Subject: 0CNN100E.H New Design

Document Number: LFPCN_PG0166

Date: Rev 08/09/2023

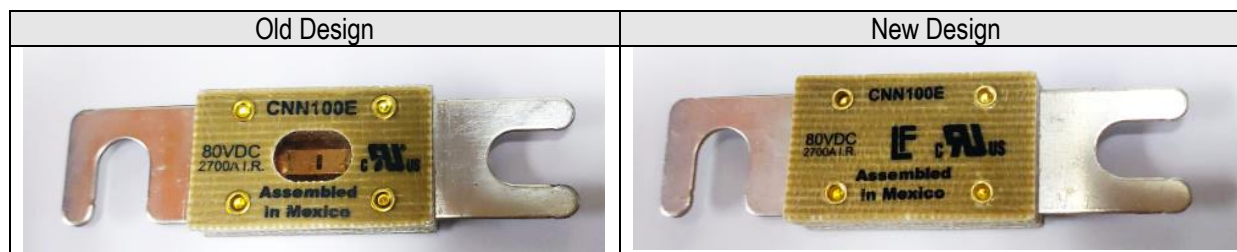
- Interrupting rating: 2700 A for same 80 VDC in the same package.
- No Mica Window for new design
- Single stamp with product information
